ERRATA SHEET

Date: 2004 Aug 17
Document Release: Version 1.0
Device Affected: P89LPC932A1

CCU.1: CCU in Alternate output mode inverting

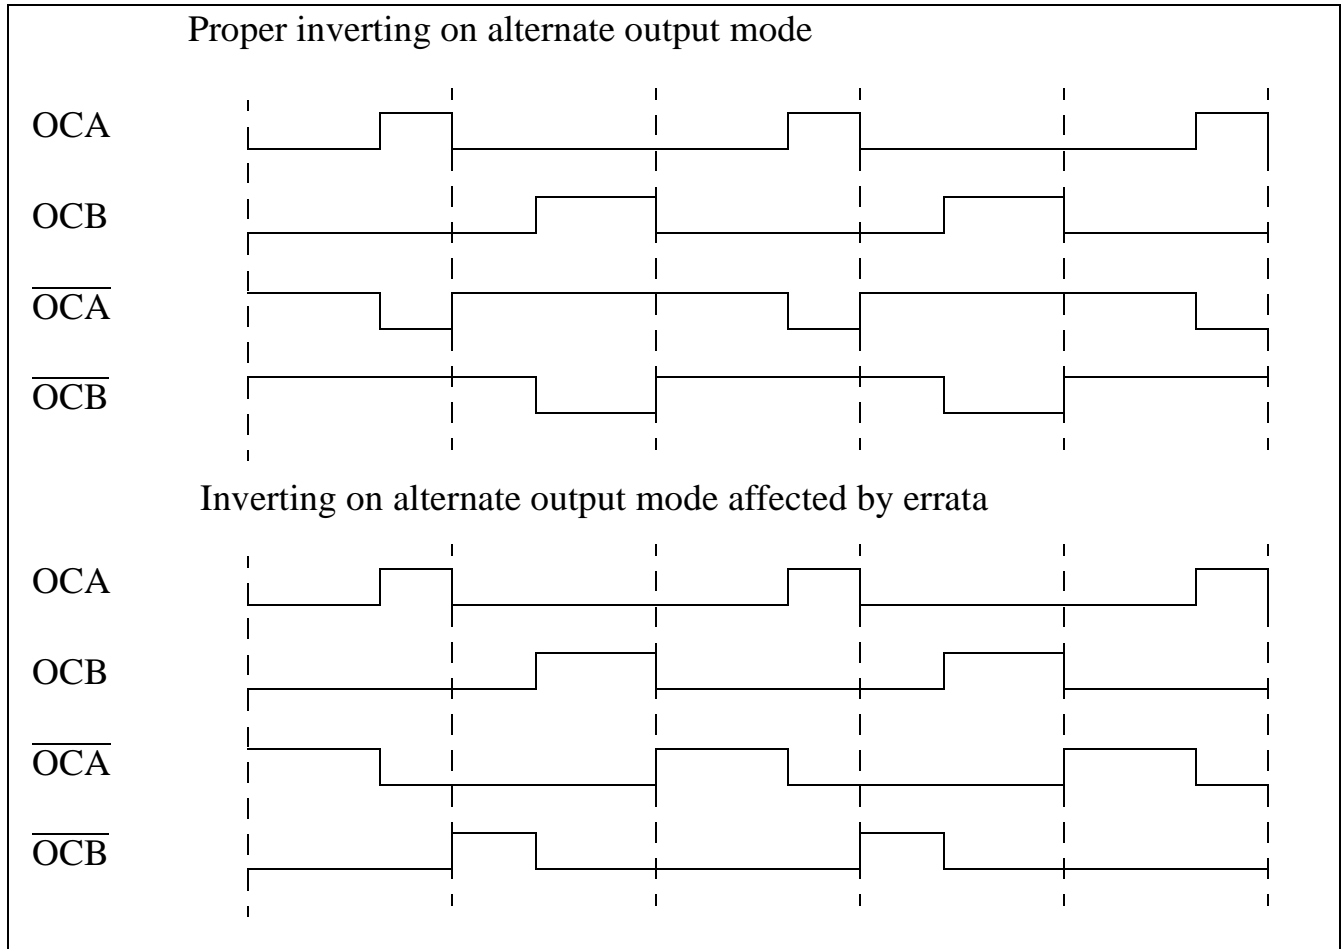
Problem: In the inactive state of the alternate output mode the inverted PWM signal is always low.

Workaround: No known workaround.

CCU.2: CCU in Alternate output mode halting

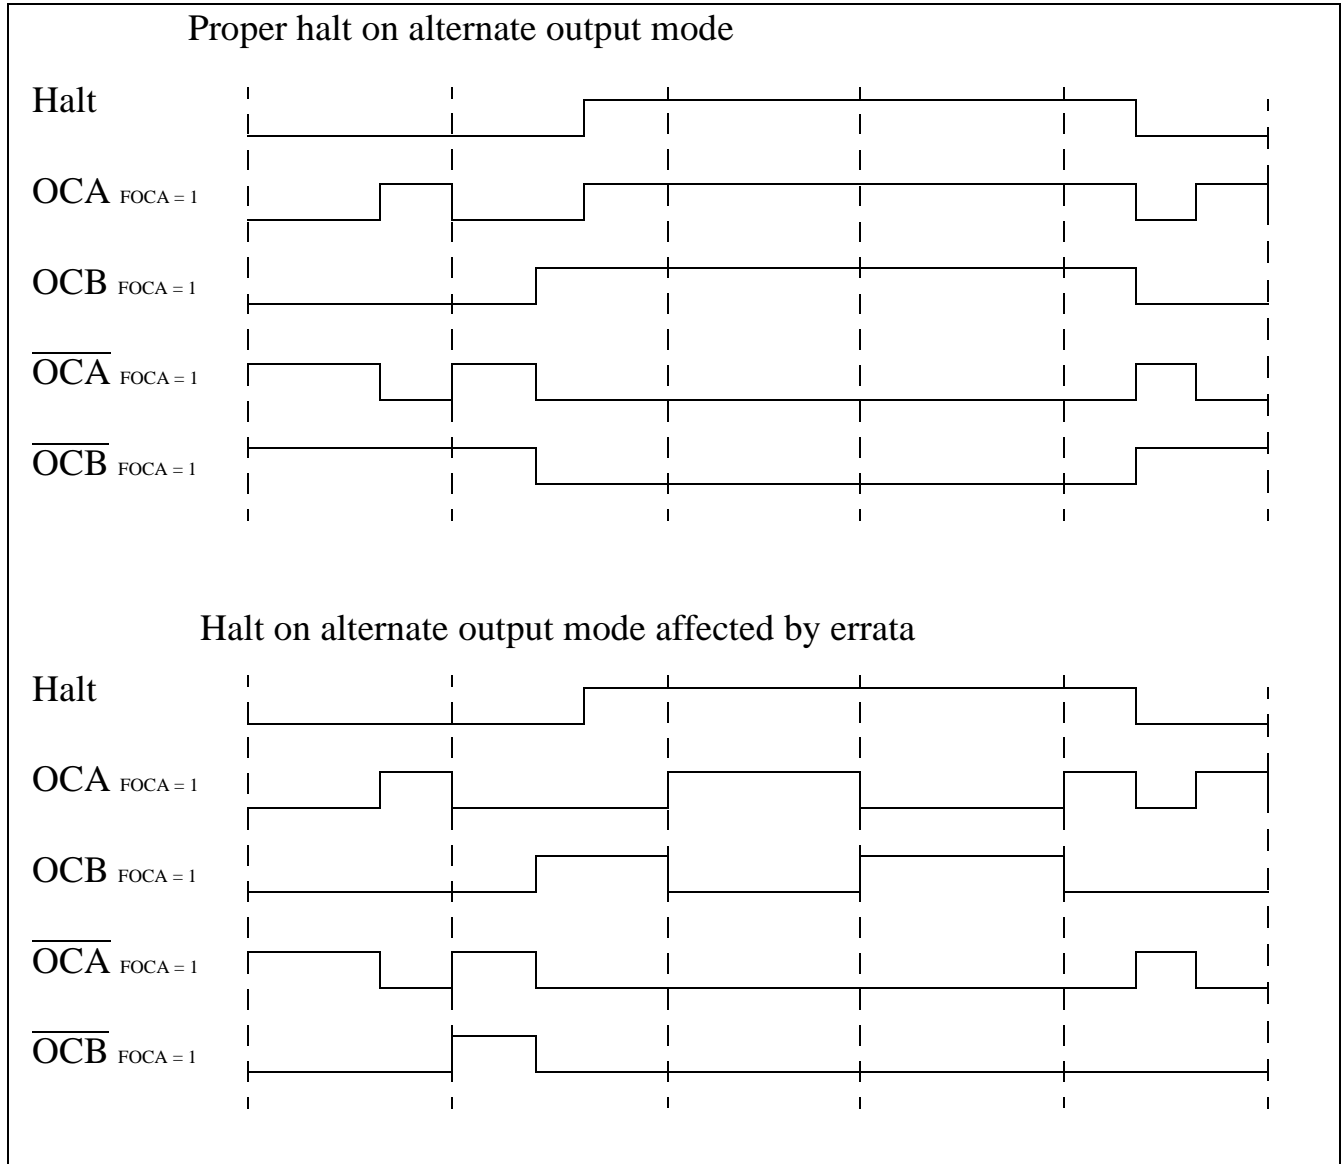
Problem: In the inactive state of the alternate output mode the inverted PWM signal is always low, even during a halt condition.

Workaround: No known workaround.
